MASONRY WALL DESIGN

**PACIFIC GAS AND ELECTRIC COMPANY
DIABLO CANYON UNITS 1 AND 2**

TECHNICAL EVALUATION REPORT

July 24, 1986

Figure A-1. Moment-Curvature Relationship for Test Panel 1A

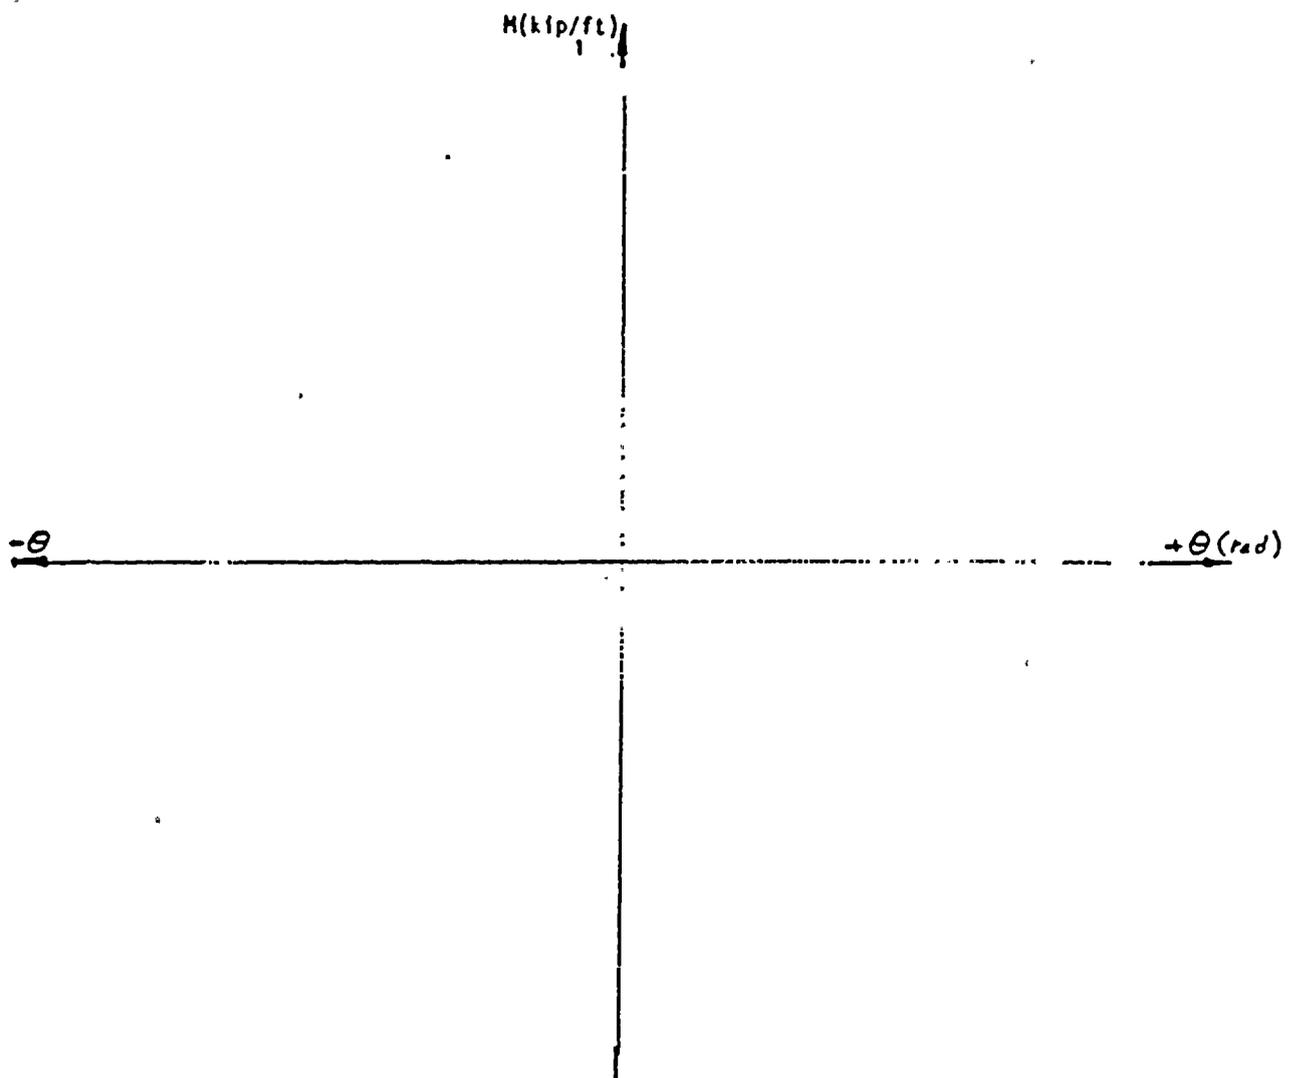
2. Inelastic Hysteretic Behavior of the Tested Walls

PG&E generated a moment-curvature response hysteresis of test panel 1A for one cycle of response based on the test measurements of rebar strains and deformations (gap measurements). This loop is shown in Figure A-1.

, the proposed method resulted in a reasonable agreement with the test results and, therefore, the Licensee's response is considered to be adequate.

Figure B-1. Moment-Curvature Relationship (Loop No. 1)

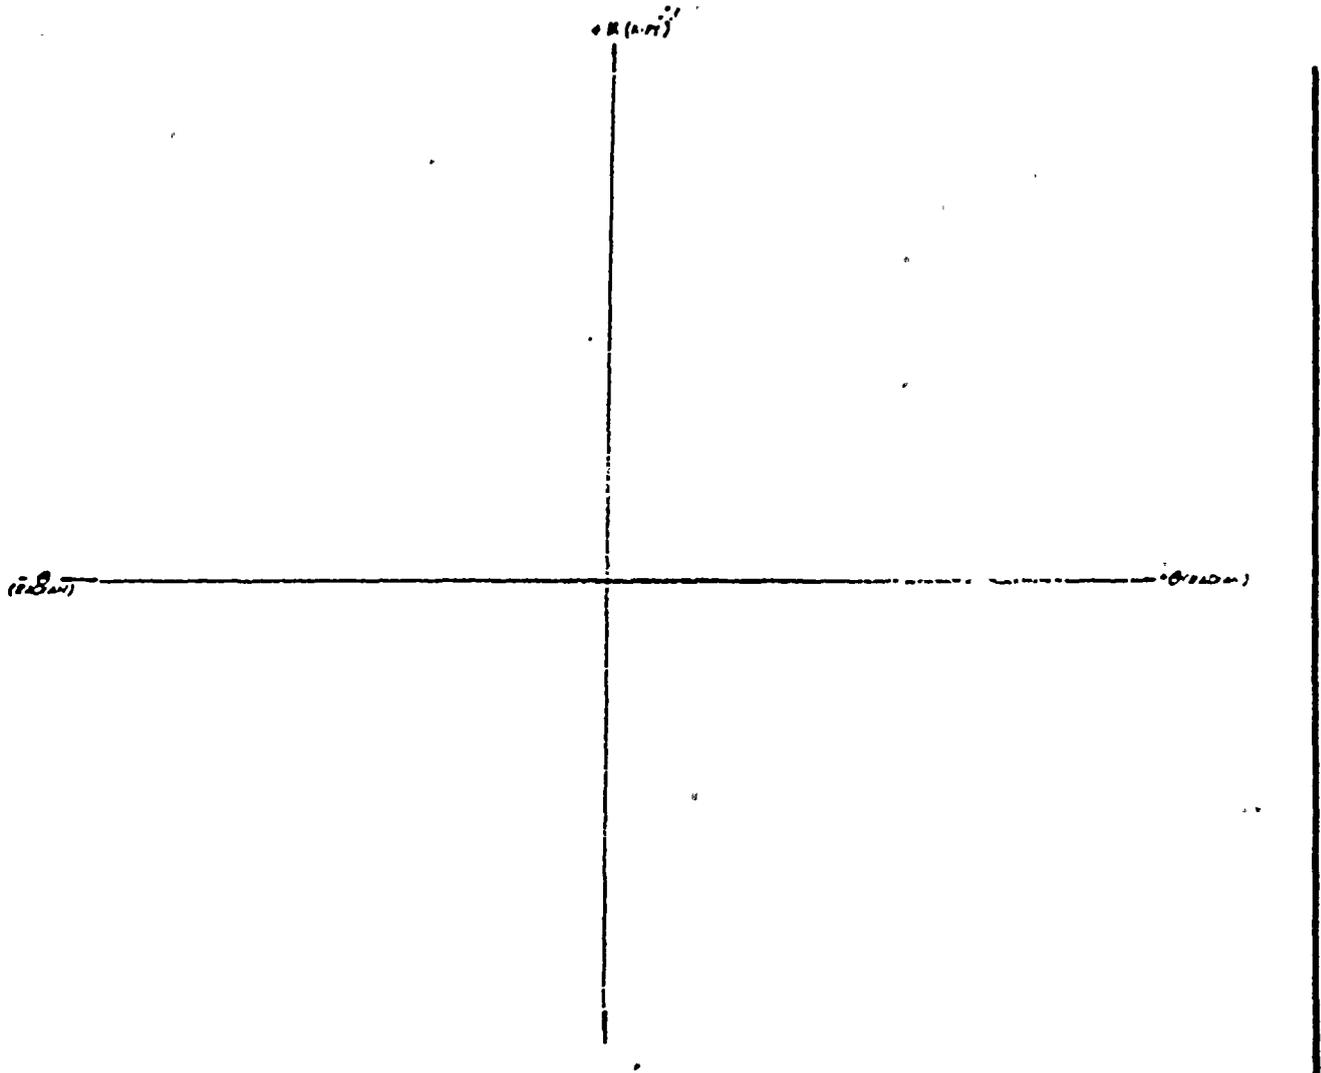
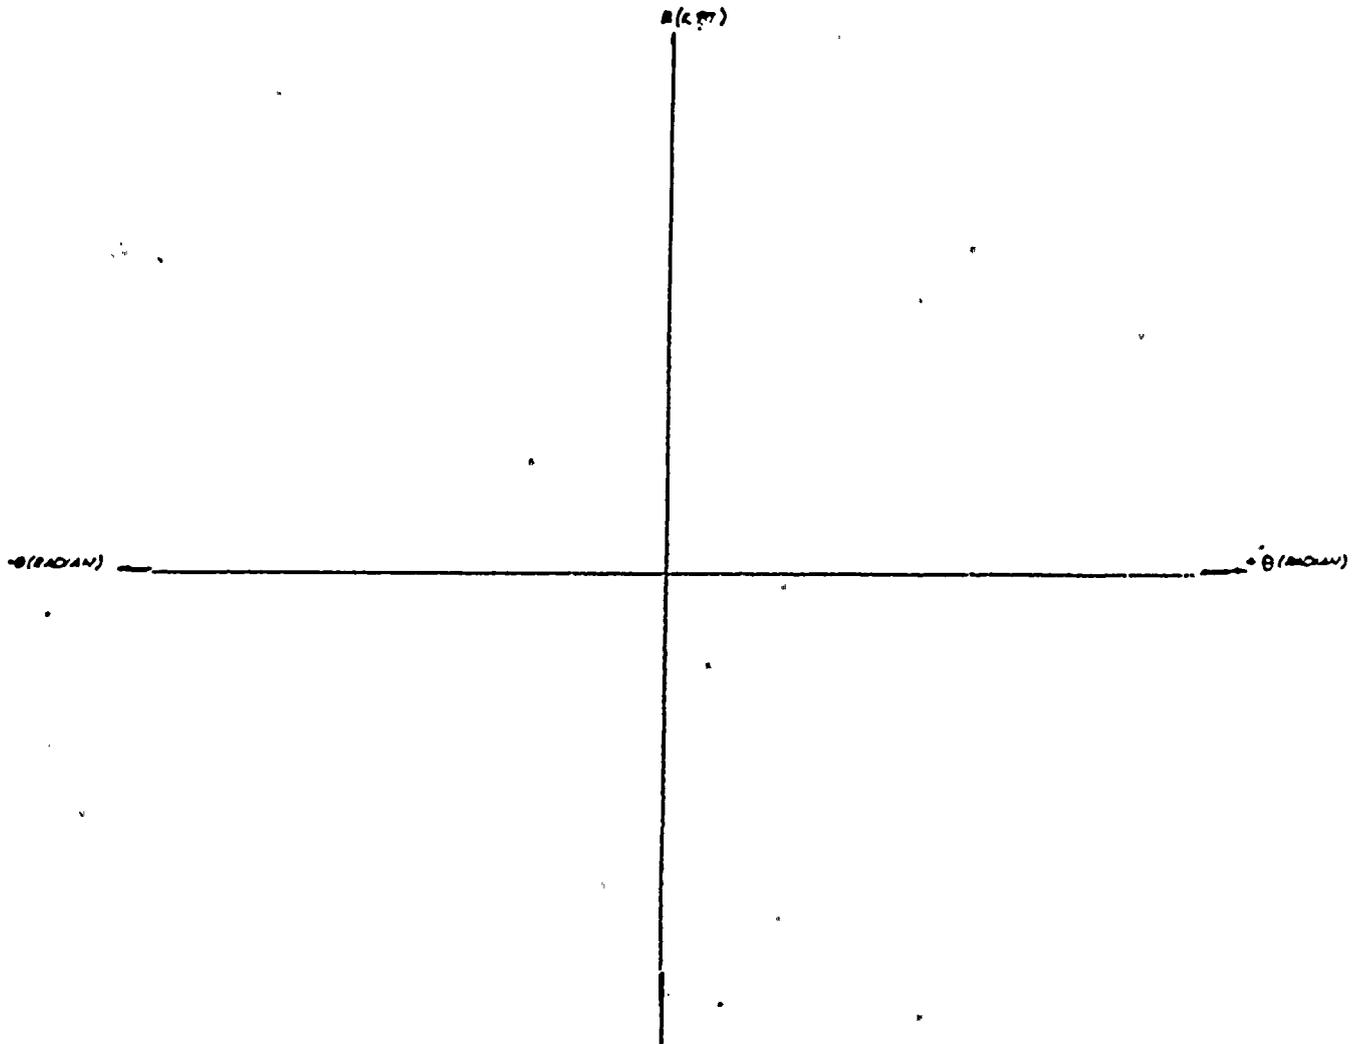
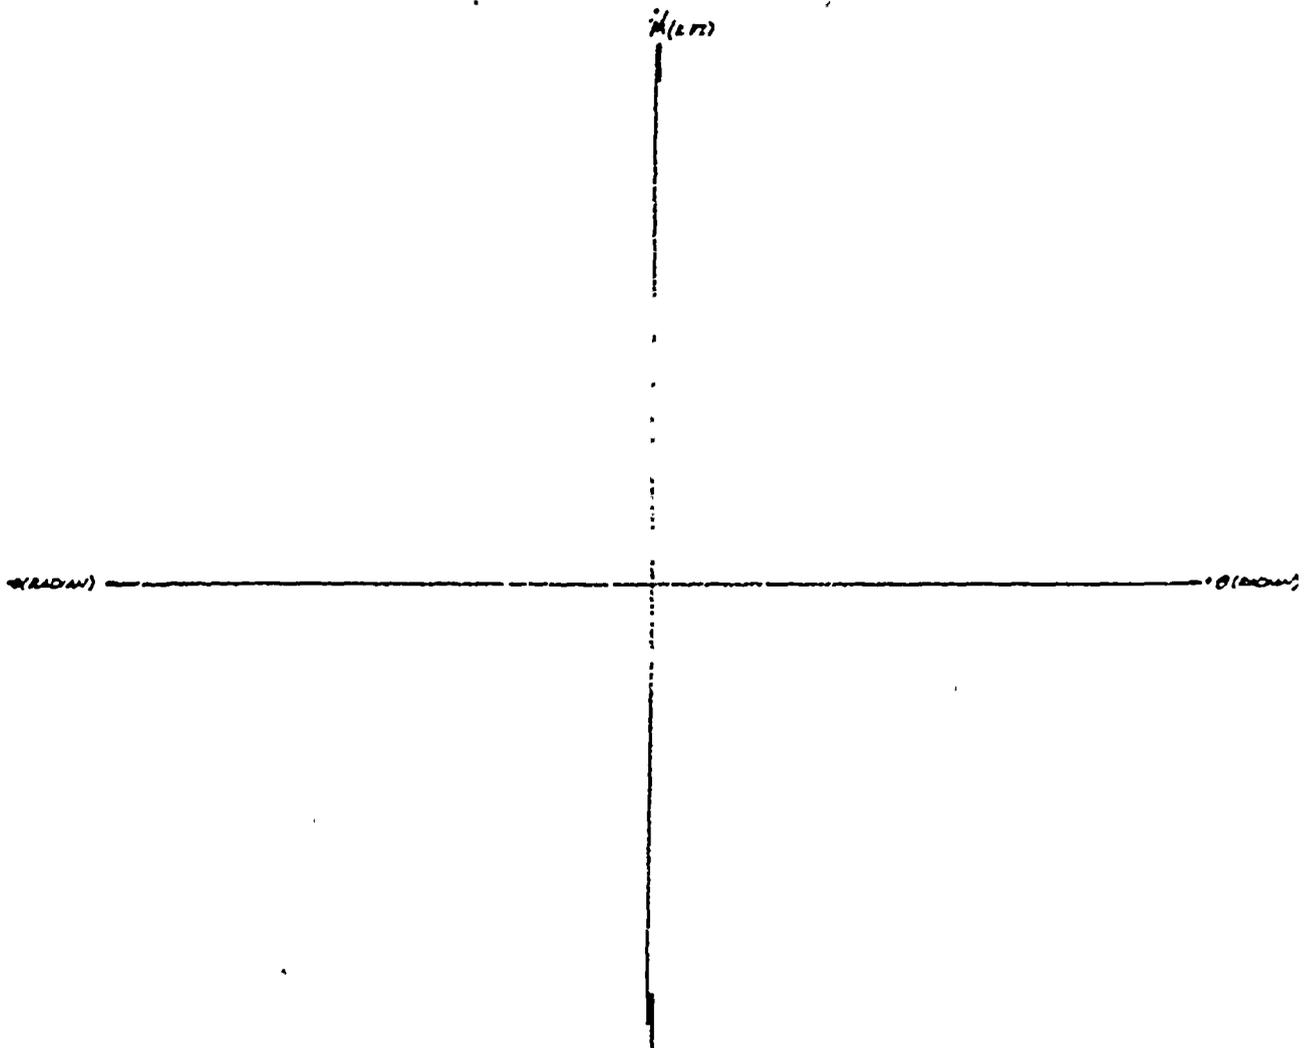
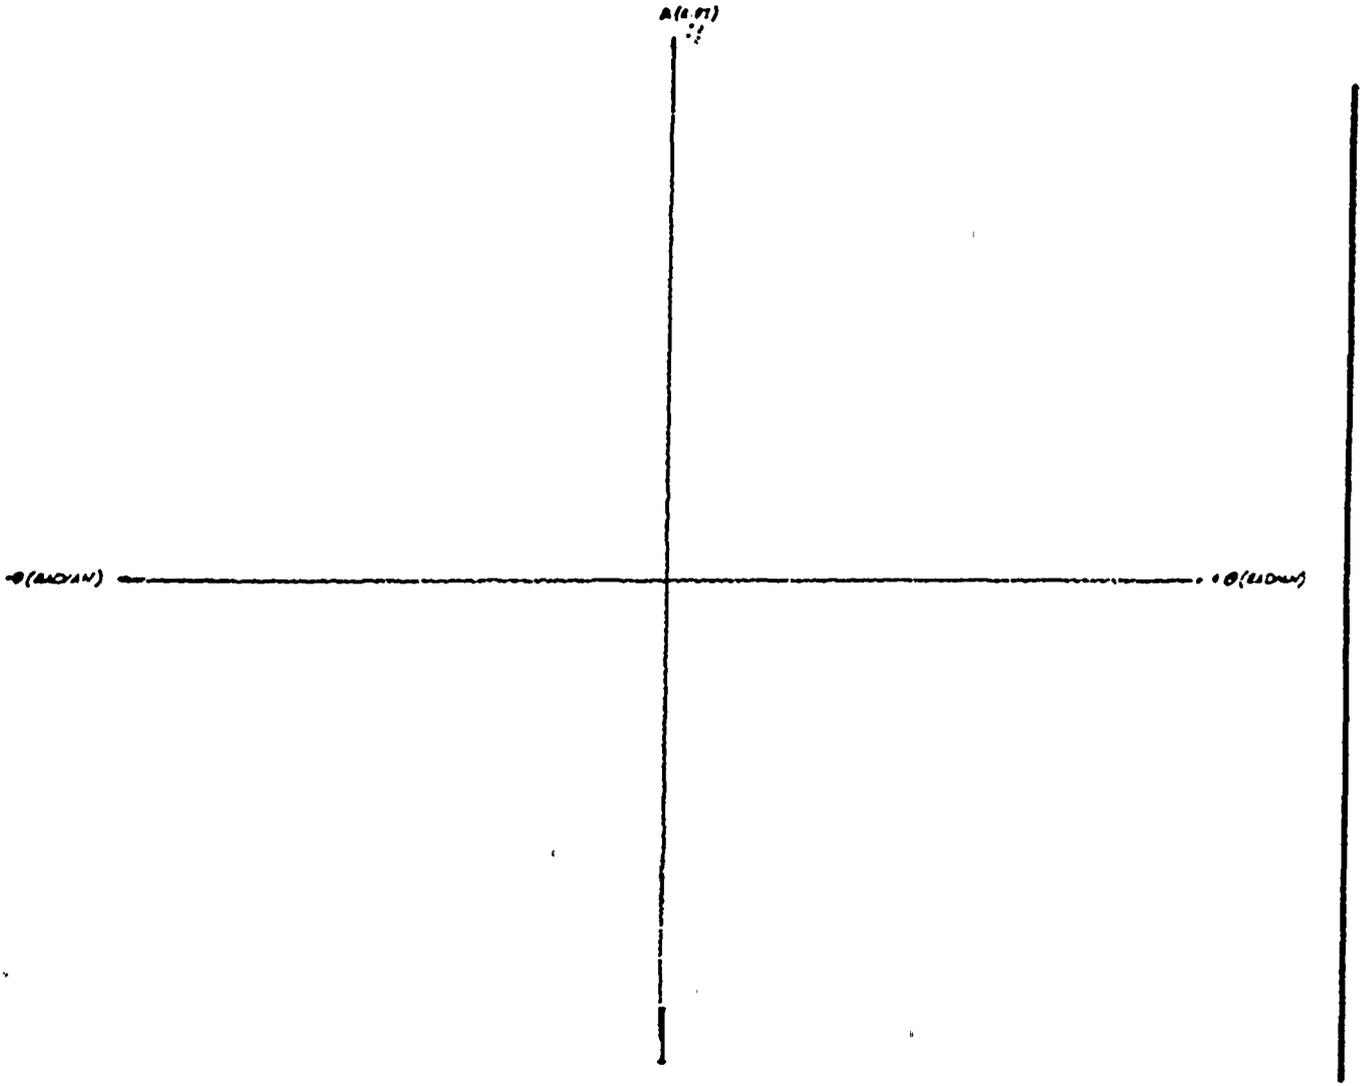
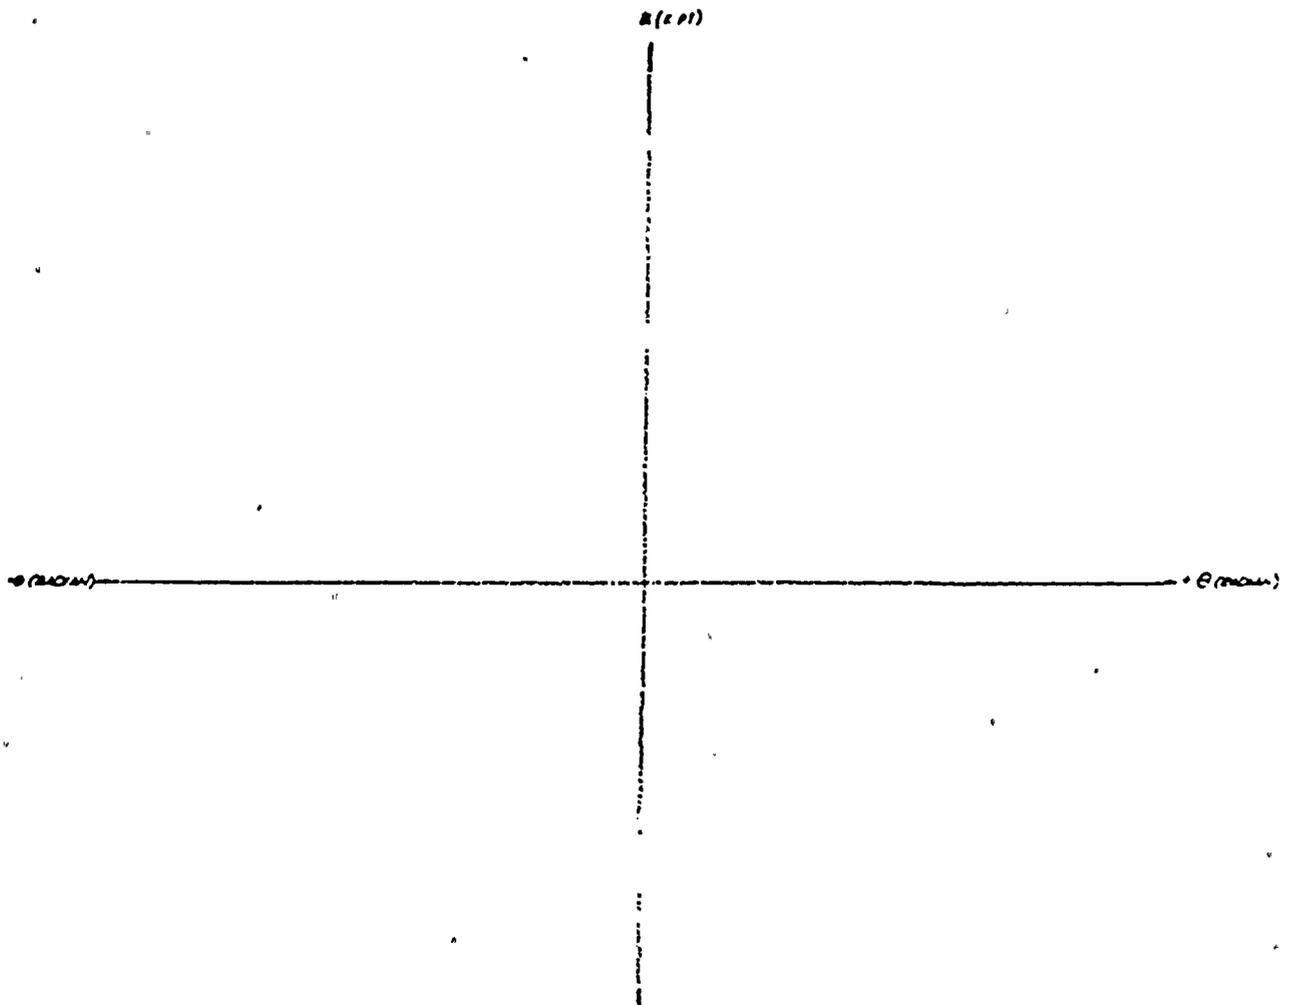
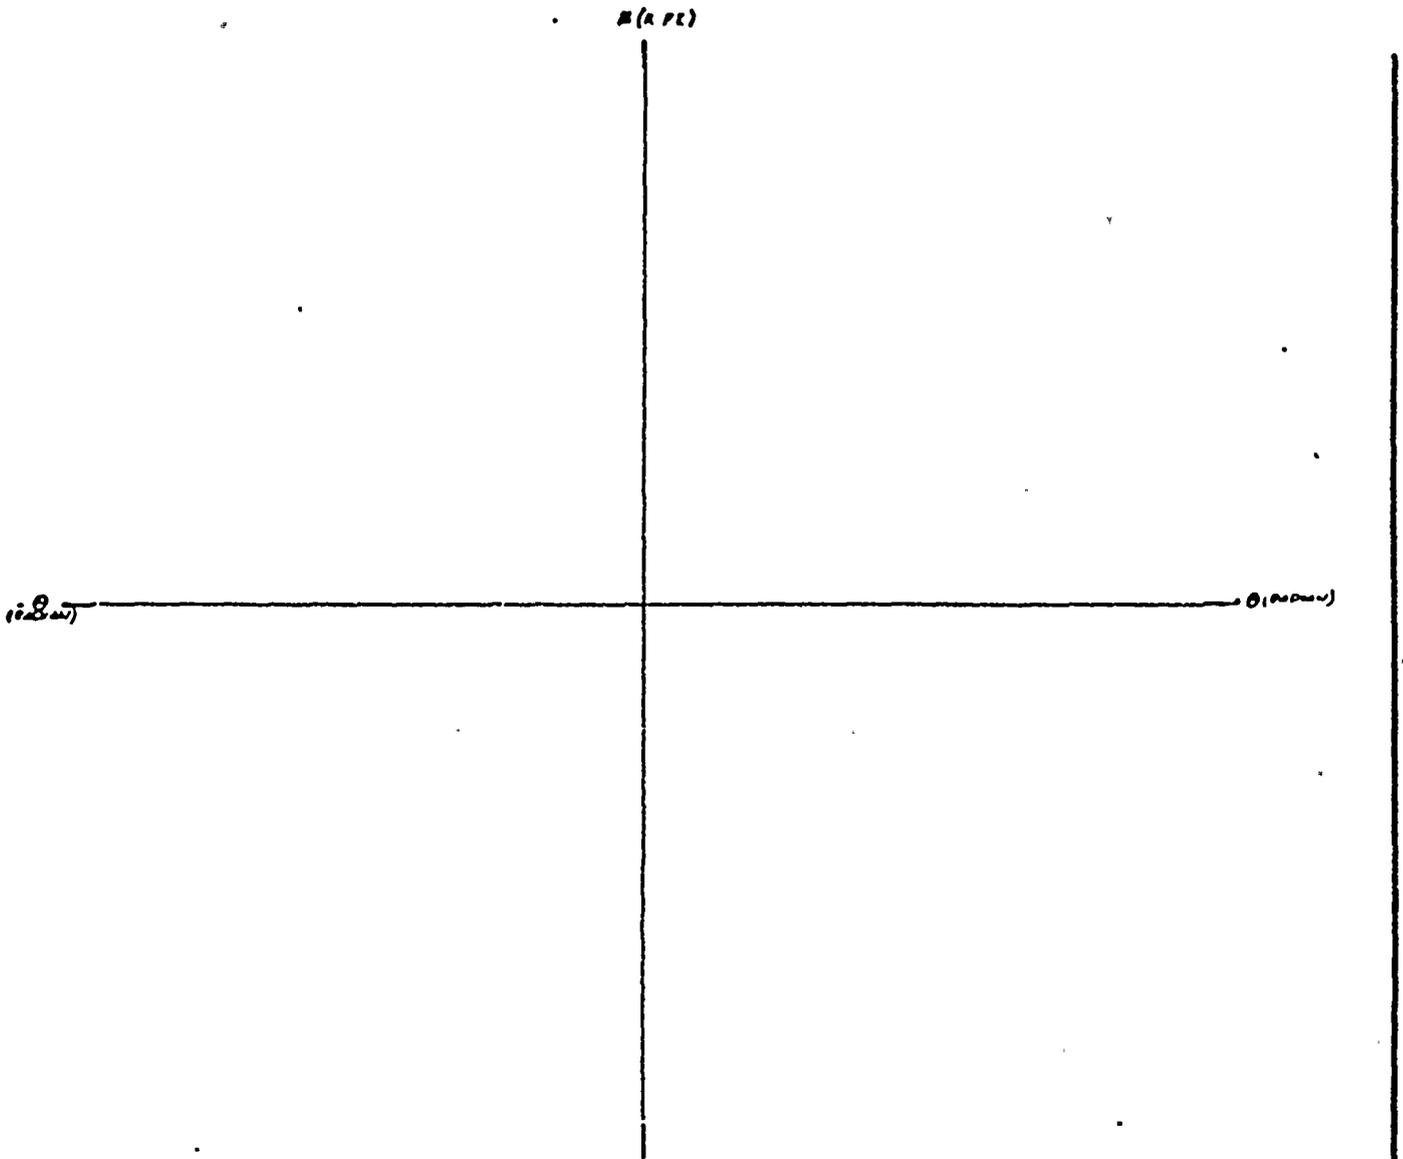
Item 1:

Provide additional data for hysteresis loops (i.e., a few more "snapshots" of hysteresis loop for the pin-pin condition).

Response 1

PG&E provided five additional hysteresis loops obtained based on panel 1A test data. Figures B-1 through B-5 show these loops, and Figure B-6 presents the superimposed plots of all loops generated. Figure B-6 indicates a stable behavior of the wall.

PG&E's response is adequate and satisfactory.

Figure B-7. Typical Details of Drypack Connection

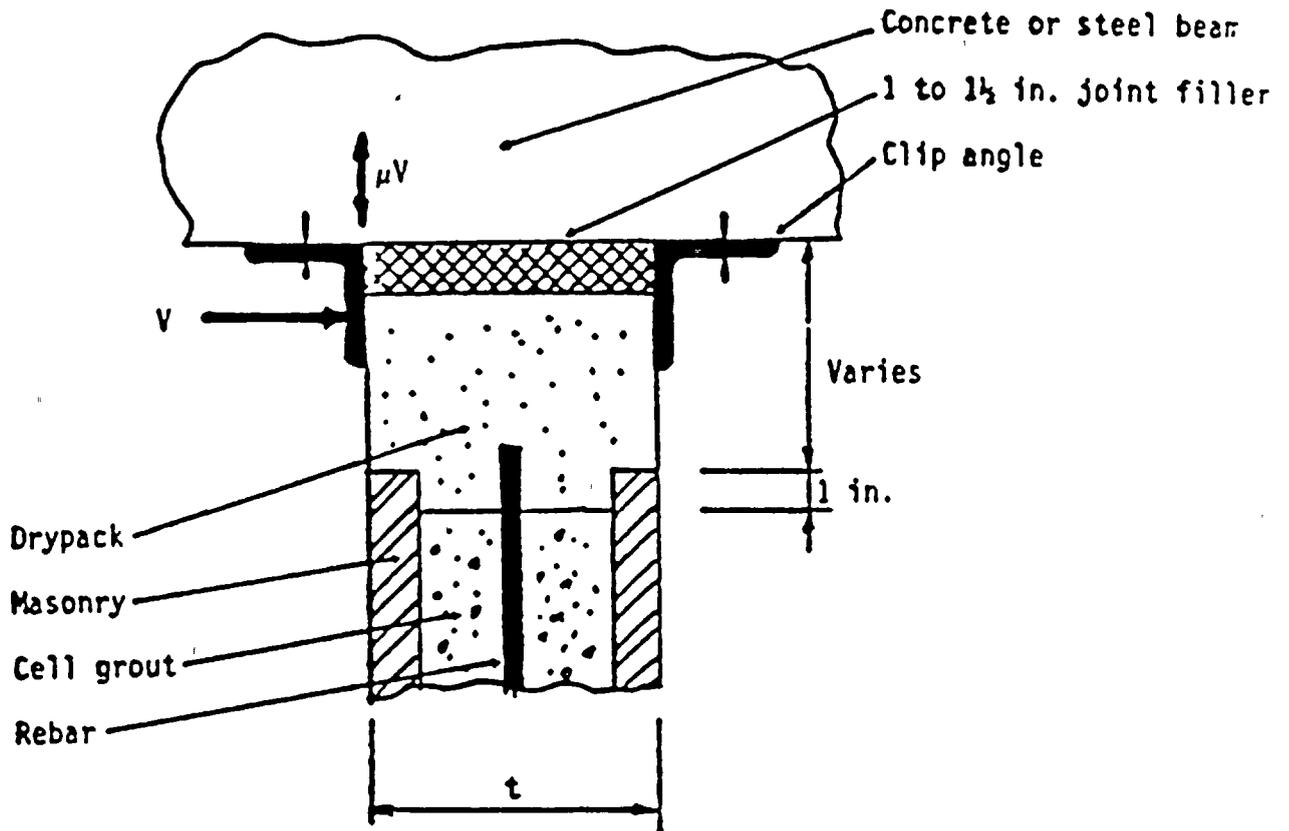
Item 7:

Discuss the shear transfer capacity for the walls where clip angles do not extend to the block but may extend to the drypack.

Response 7

The Licensee stated that the drypack material has a minimum specified compressive strength of 4,000 psi, whereas the masonry compressive strength is 1950 psi, which was used for the drypack evaluation. The calculated shear stress for walls with drypack was compared with the ACI-531-79 code allowables and resulted in three groups with different safety of factors as described below:

PG&E strengthened Group III walls with vertical steel beams supported by the floor slab at the top and bottom of the beam. A typical detail of drypack connection is provided in Figure B-7.

It is judged that the top connections of these walls have adequate shear transfer capacity.
